SUBJECT: ADEQUACY OF STATION ELECTRIC DISTRIBUTION VOLTAGE

SAFETY EVALUATION  
H.B. ROBINSON STEAM ELECTRIC PLANT, UNIT NO. 2  
DOCKET NO. 50-261  
ADEQUACY OF STATION ELECTRIC DISTRIBUTION SYSTEM VOLTAGES

TECHNICAL EVALUATION REPORT ON THE  
ADEQUACY OF STATION ELECTRIC DISTRIBUTION  
SYSTEM VOLTAGES FOR THE  
H. B. ROBINSON STEAM ELECTRIC PLANT, UNIT 2

July 22, 1983

FIGURE 1 - H. B. ROBINSON STEAM ELECTRIC PLANT, UNIT 2  
ELECTRICAL ONE-LINE DIAGRAM

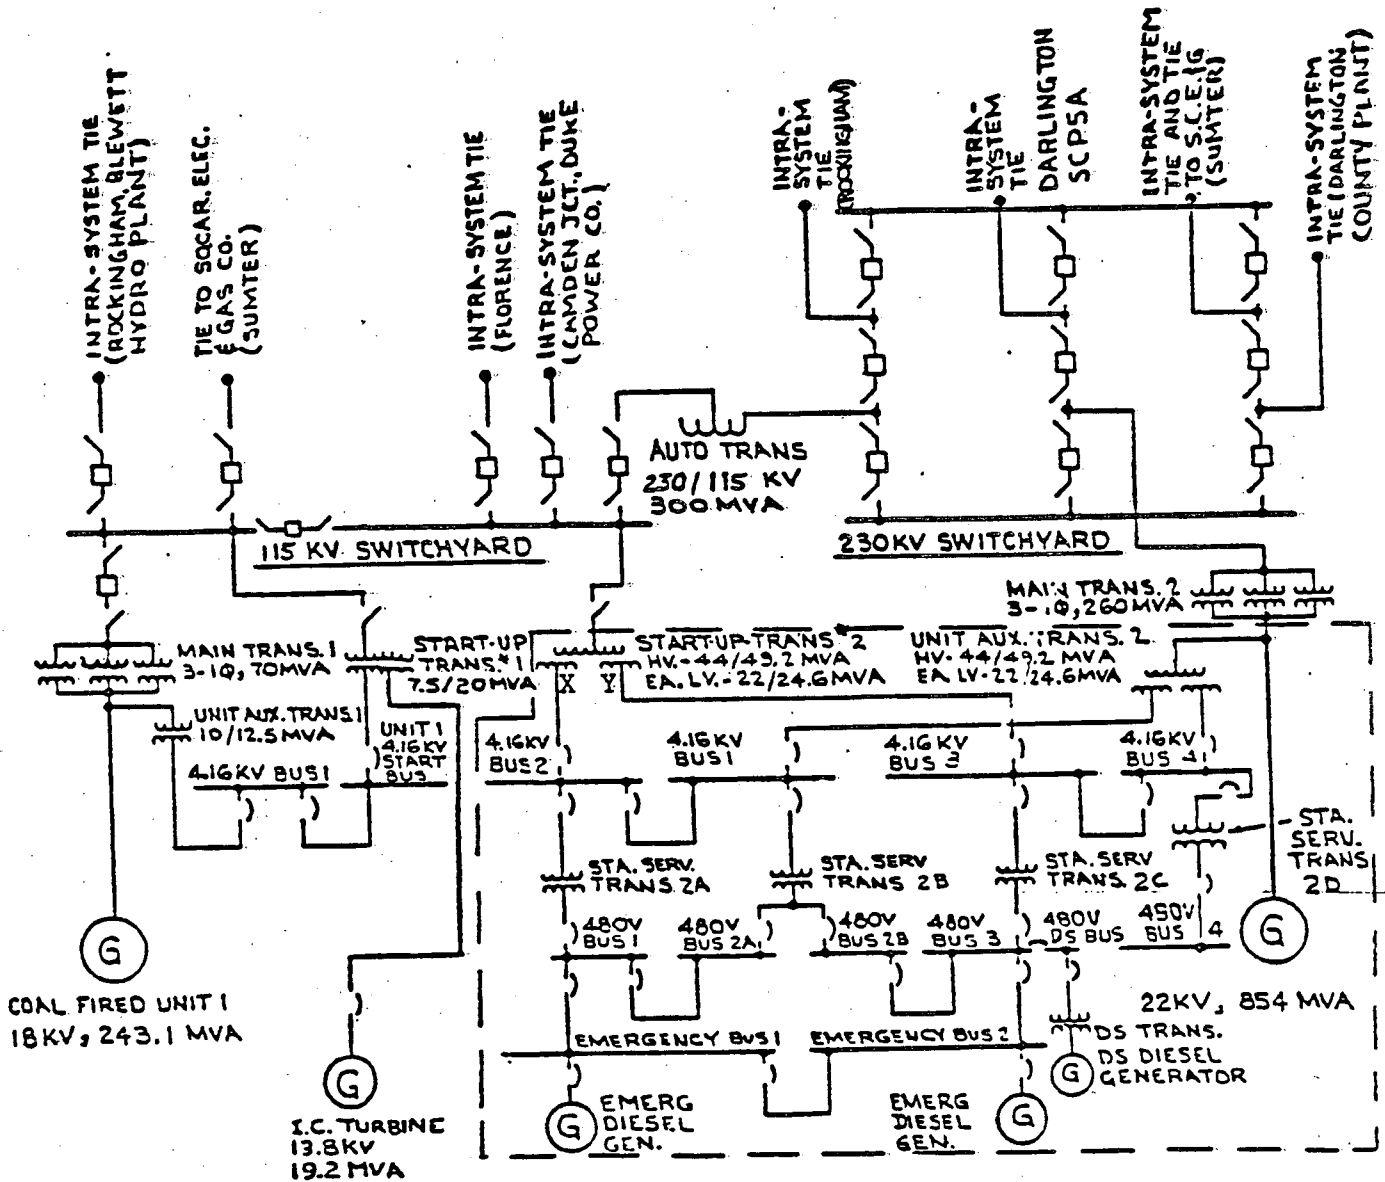
In Figure 1, two offsite circuit paths to the onsite distribution system exist through startup transformer No. 2 and by backfeeding through the main transformer bank No. 2 and the unit auxiliary transformer No. 2. As stated in the plant's updated FSAR, the loss of the single startup transformer would result in putting into service a spare SUT (minimum of 24 hours) or by backfeeding through the main/unit auxiliary transformers (minimum of 4 hours). The licensee has revised the 4 hours to a more realistic time of

16 hours to accomplish the backfeeding [Ref. 5]. The licensee states that no event or condition could cause the loss of both circuits [Ref. 5]. However, the GDC 17 criterion assumes the "loss of all onsite alternating current power supplies". Therefore, the licensee has not demonstrated, and is required to, that in the minimum time frame from 16 to 24 hours (no AC power available), that the reactor could be maintained in a safe condition until the restoration of at least one offsite circuit is accomplished.

- (2) Update the plants FSAR and incorporate limiting conditions for operation in the Technical Specifications on the use of back-feeding through the main/unit auxiliary transformers to the Class 1E buses. Should also include any administrative controls.
- (3) Include in the design modification for the bypassing/reinstatement of the degraded grid protection scheme during RCP starting, a failure-to-reinstate alarm or provide for automatic bypassing/reinstatement.
- (4) Results of the in-plant tests for verifying the acceleration times of the starting loads used in the voltage profile analyses.
- (5) Demonstrate that during the minimum time frame of 16 to 24 hours necessary to restore at least one offsite source (no onsite sources available), the reactor can be maintained in a safe condition.
